LORMEL DEVELOPMENTS (BRADFORD) LTD.
PURCHASER EXTRAS

LOT - 100 P.E #002 – KIMBERLEY - 3020 (CORNER)

Schedule B-3 – Purchaser’s Extras

PROJECT
PROPOSED
TWO STOREY DWELLING
FOR: LORMEL HOMES
AT: BRADFORD

DRAWING
FIRST AND SECOND
FLOOR PLANS

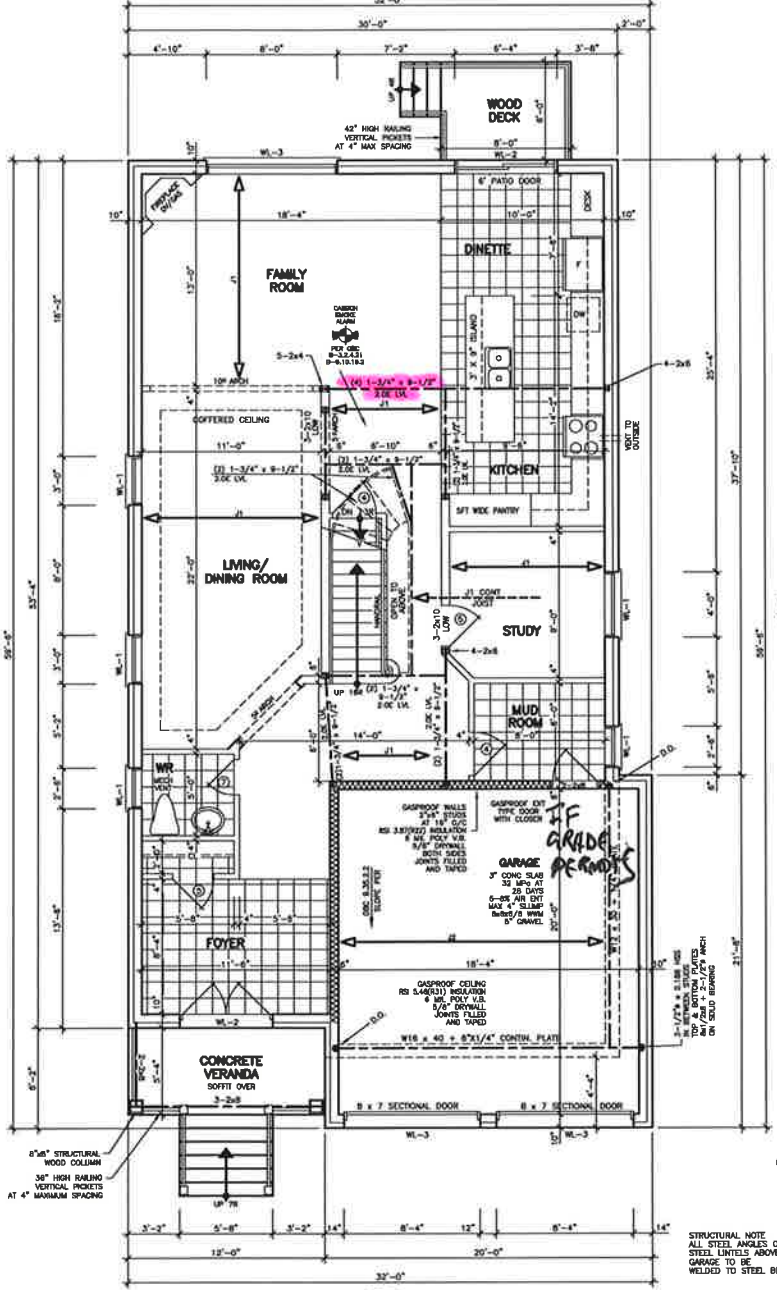
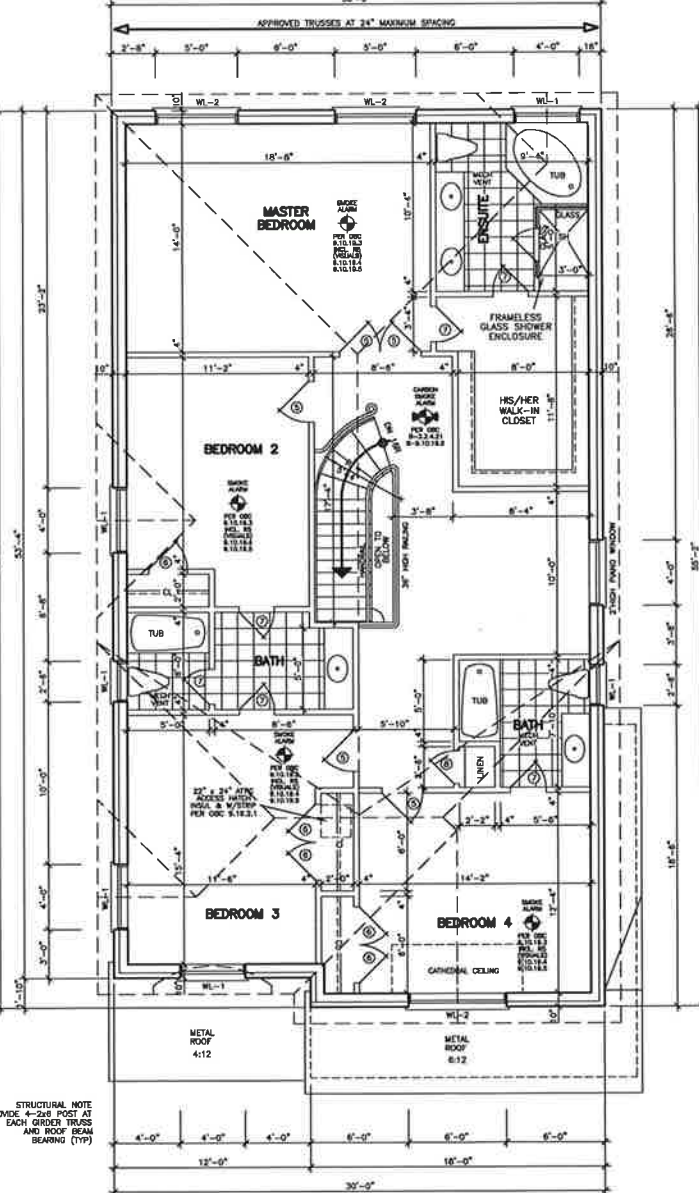
No.	DESCRIPTION	PRICE
1.	Relocate the laundry connections and the laundry tub to the basement. Location as per sketch	
2.	Purchaser requests to that the laundry room is not sunken - to remain as the same level as the rest of the main floor. The Purchaser udnerstands and acknowledges that by doing so - the door from house to the garage may be affected and cannot be installed.

3.	Delete trimmed archway between the kitchen and main hallway; between dinette and family room. Provide a trimmed opening as wide as possible between the family room and kitchen. In lieu fo a solid wall between the dining room and family room, provide for trimmed opening - to be as wide as possible. (wb)

4.	Relocate the fireplace, as per sketch	
5.	In lieu of peninsula in kitchen, provide and install L-shaped kitchen with island, (approximately 6.8ft of upper and lower cabinetry added on stove wall. Relocate the sink to the island. Dishwasher to be located on Stove wall. Note - Purchase will be installing a 36" stove/hood fan. Provide and install counterdepth fridge enclosoure, as per sketch. Cost includes buider's standard cabinetry and granite top.	
6	Island to be 2x9 with extended flat bar top (3x9). Cost includes the Builders standard cabinetry and granite top

7.	Provide desk between fridge enclosure and the rear wall. Desk to have two pull out drawers and completed with granite top from Builders's standard samples

8.	In lieu of upper and lowers on original fridge wall, provide and install 5ft of pantry (2ft deep)	
9	Kitchen island is fixed, therefore in addition to standard, provide and install two electrical outlets in the island. (outlet to be on the rear side of the island) Purchaser may be proceeding with a waterfall countertop. Confirmation of locations will be provided upon final review of kitchen layout.	
10	Relocate the door from the master bedroom closet to the master bedroom, as per sketch	
Brown R50		
H.S.T.		
New Total:		
Less Bonus Package (if Applicable)		
TOTAL:		
Net upgrades continued on page 2		
TOTAL
